## Department of Transportation

#### MEMORANDUM

**SUBJECT:** ZC Case No. 21-26 – 301 Florida Avenue NE

**Figure 1 | Site Plan**

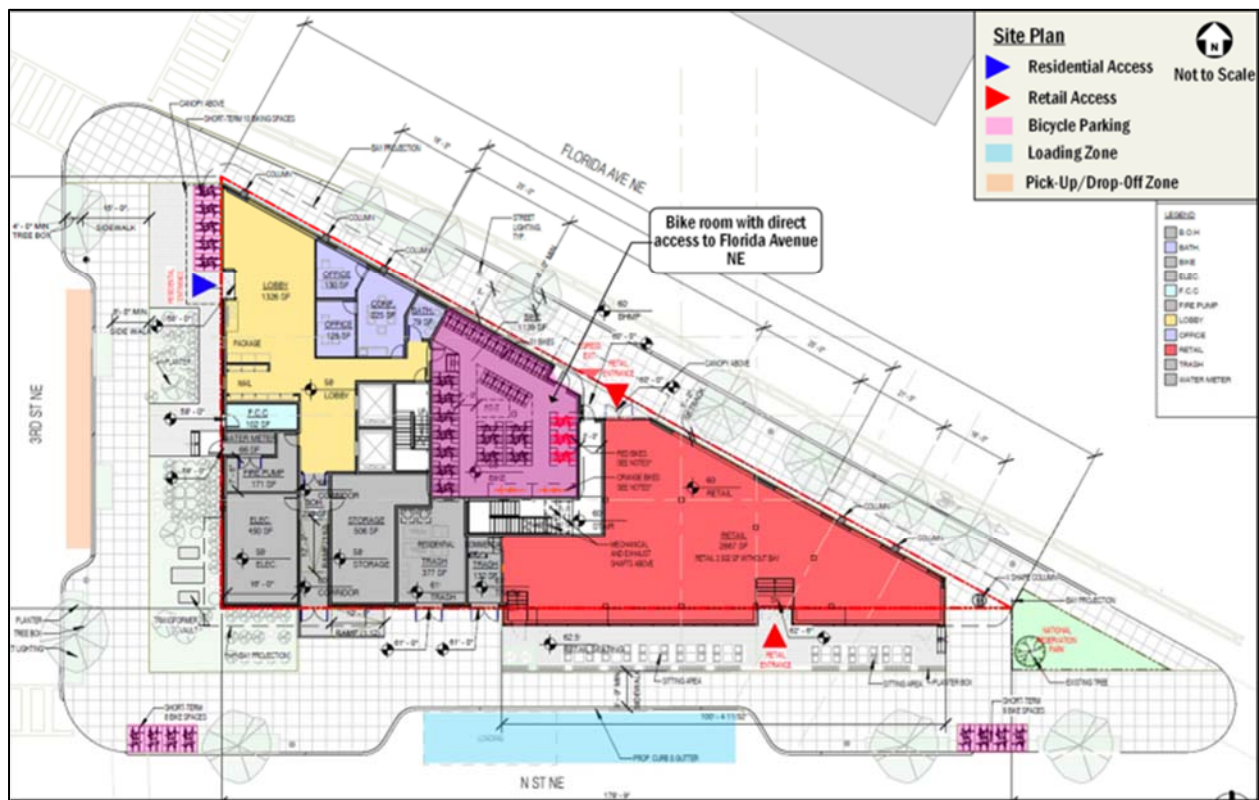
While the preliminary public space plans, shown above in Figure 1, are generally consistent with DDOT standards, there are several considerations that need to be reviewed in greater detail during the public space permitting process:

- Provide a curbside management and signage plan during permitting. Loading zones proposed on N Street and 3<sup>rd</sup> Street must meet DDOT standards and are subject to potential refinement. The proposed raised concrete loading zone with hatched striping does not meet DDOT standards;

- There should be a row of street trees on both streets (currently a row of trees is not shown on N Street). This may result in narrowing the width of the sidewalk to 6 feet, shrinking the depth of the loading zone by 2-3 feet, and adding in tree boxes;

- To achieve a sidewalk of at least 6 feet in width on Florida Avenue, approximately 1-2 feet should be provided on private space;
- No new curb cuts to the property from 3<sup>rd</sup> Street, N Street or Florida Avenue should be proposed. The four (4) existing curb cut on the property should be removed;

- DDOT supports the inclusion of curb extensions on the corners to narrow the roadway, slow traffic, and enlarge the size of the pedestrian realm;
- Maximize the amount of green space provided in public space, particularly on N and 3<sup>rd</sup> Streets;

- Ensure that there are no doors swinging into sidewalk space. Currently, there are several doors shown opening outward into public space. These should either be recessed into the building or 'protected' on each side by building projections or planters; and
